Square Guidelines: SQ. 225

GUIDELINES GOVERNING APPROVAL OF DEVELOPMENT PROJECTS

We have reviewed the descriptive booklet dated August 25, 2011 that summarizes the proposed redevelopment of 1301 Pennsylvania Avenue, NW (Lot 835, Square 254) and the Plan and Square 254 guidelines. It is our view that no amendment is required for the redevelopment of Lot 835. The proposed massing of the new building is consistent with the recommendations and requirements in the square guidelines in its observance of the E Street building line, setback, and height.

The General Services Administration has submitted a proposed amendment to the Pennsylvania Avenue Development Corporation Square Guidelines for Square 254. The amendment proposes to remove the requirement for arcades along the E Street building line for the Square. The amendment would support a proposal to redevelop the office building on the corner of 13th and E Streets, NW with a building built to the property line and having glass store frontages rather than the use of an arcade.

Current Square Guidelines

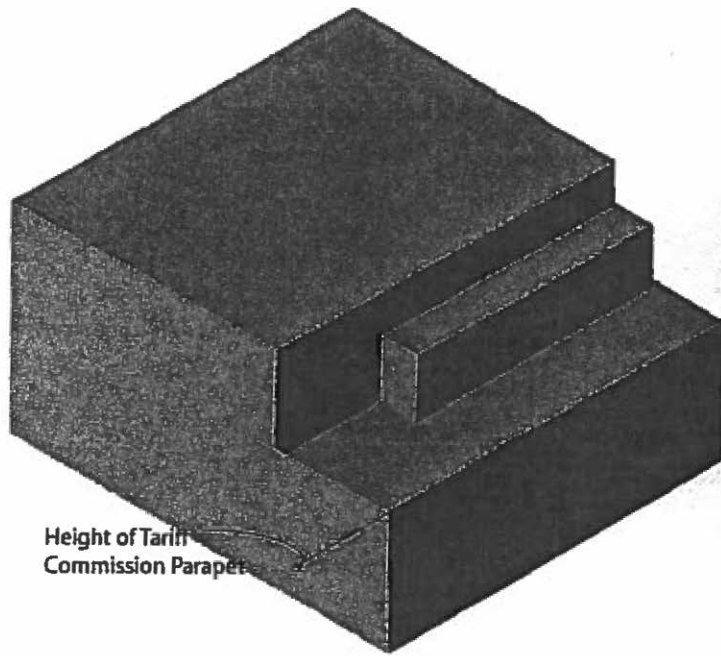
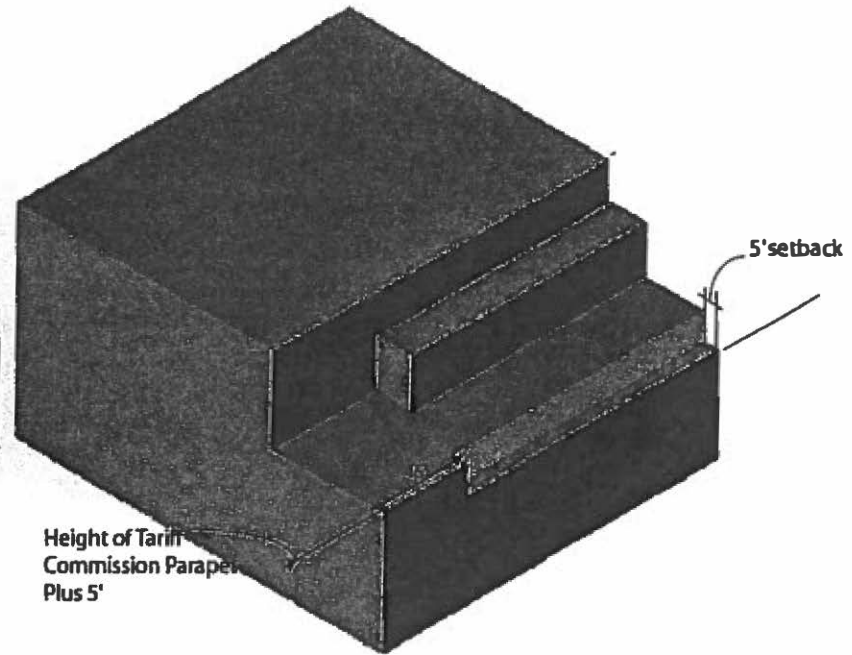
In accordance with the attached plans, we are proposing a project which will maintain the cornice height of 60 feet (except at the corner), but the height of the building would be permitted to reach a roof height of 65 feet after a five foot setback from the 8th Street facade. The Plans for the project, prepared by Hartman-Cox Architects, are attached as Exhibit 1.

In order to accommodate the design proposed in Exhibit 1, we propose the following language for the revised Square 406 Guidelines:

Attached as Exhibit 3 is a diagrammatic depiction of the proposed new Guidelines. Please begin the process necessary to effectuate the plan amendment. Please call if you have questions or comments.

6th Floor Plan

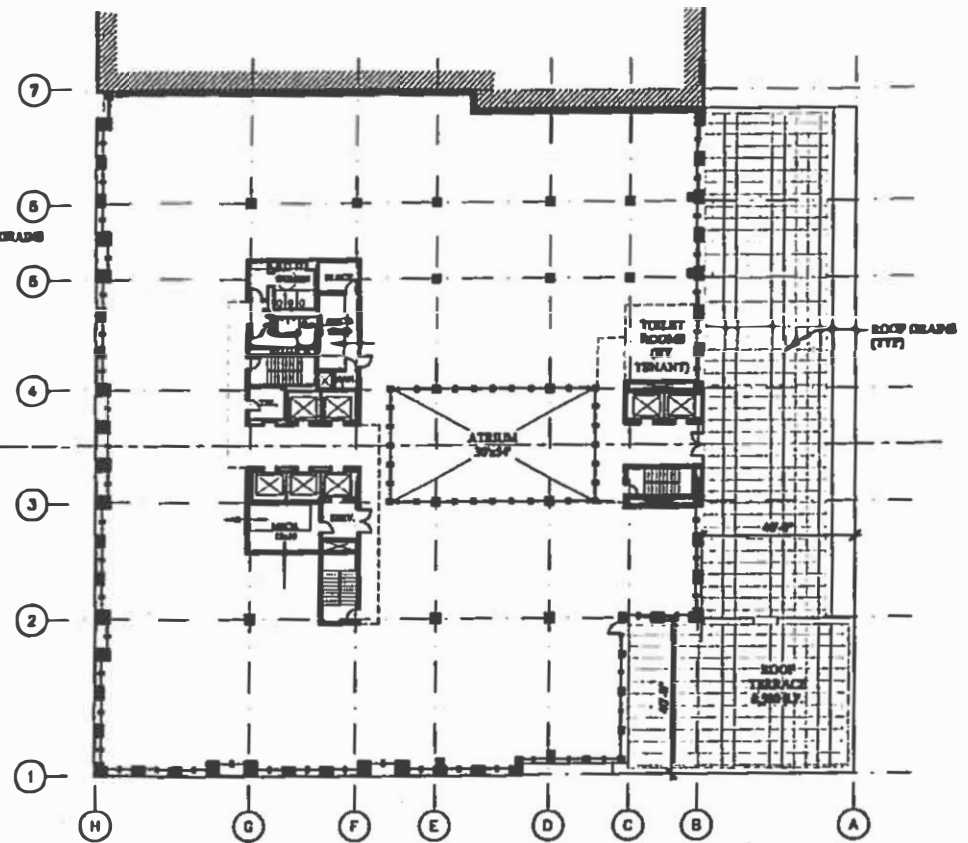
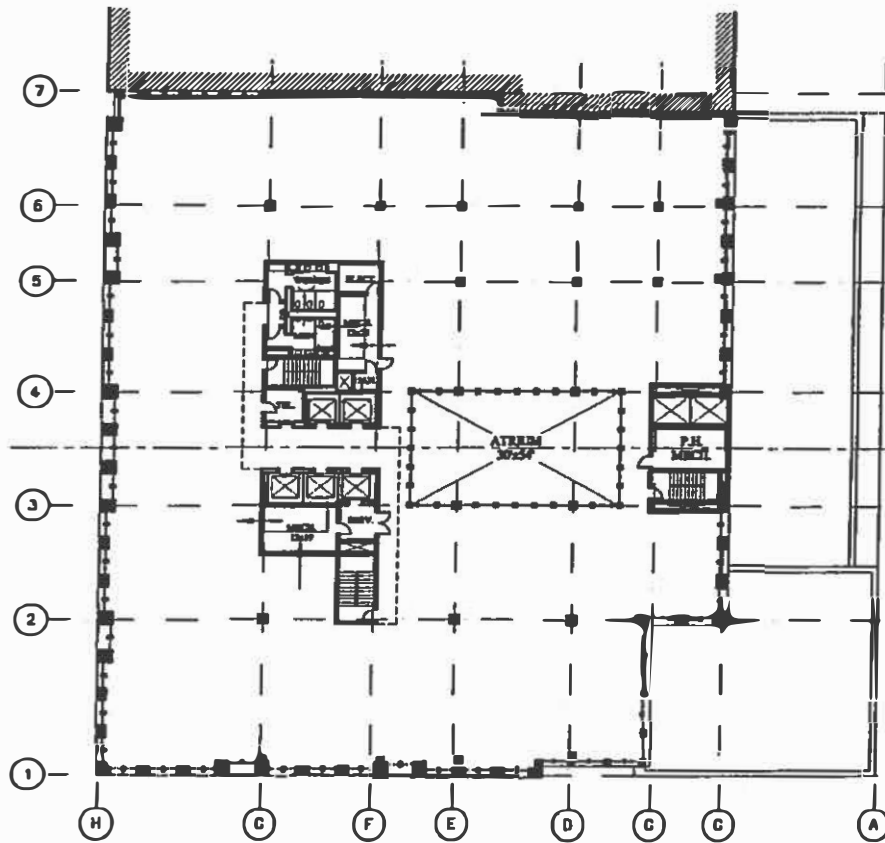
The 6th floor plan shows the proposed additional square footage on this floor, with the proposed 5' setback (starting 45' north of the southeast corner of the building) to respond to the parapet height of the Tariff Commission Building. The 7th floor plan shows both 40' setbacks (from 8th Street and from E Street) required in the current square guidelines and maintained in this proposal.

8th Floor Plan

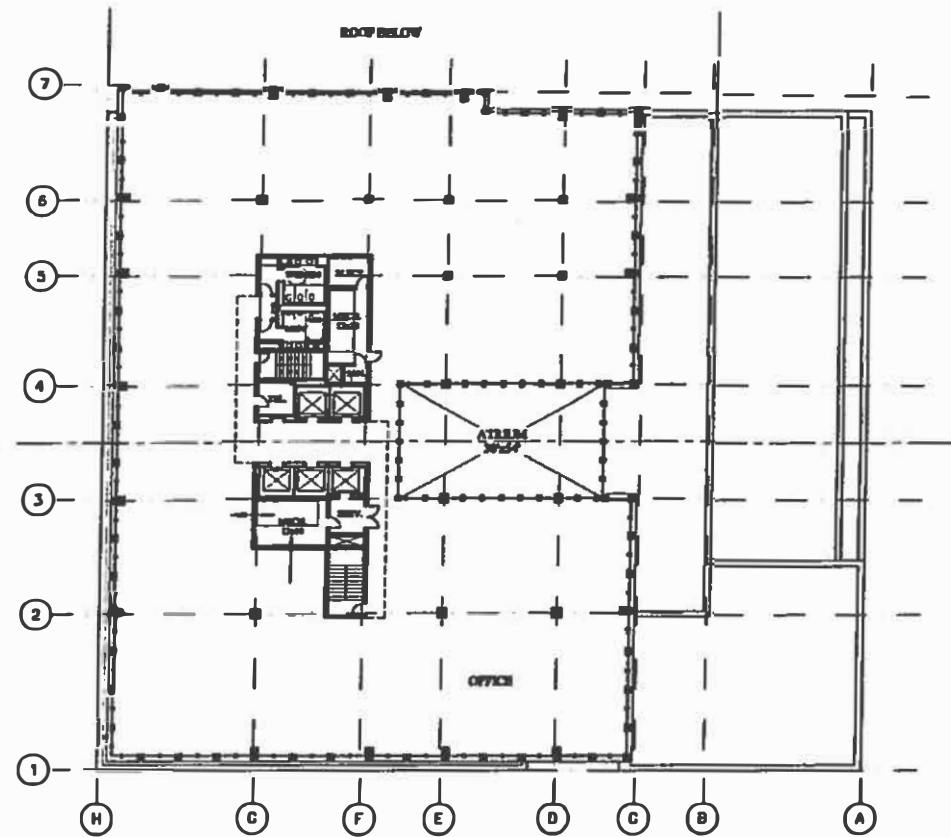
There are no changes to the square guidelines proposed above the 6th floor. The 8th floor plan maintains the guidelines' required 40' setbacks. The 9th and 10th floor plans show, in addition, the required 60' setback from 8th Street.
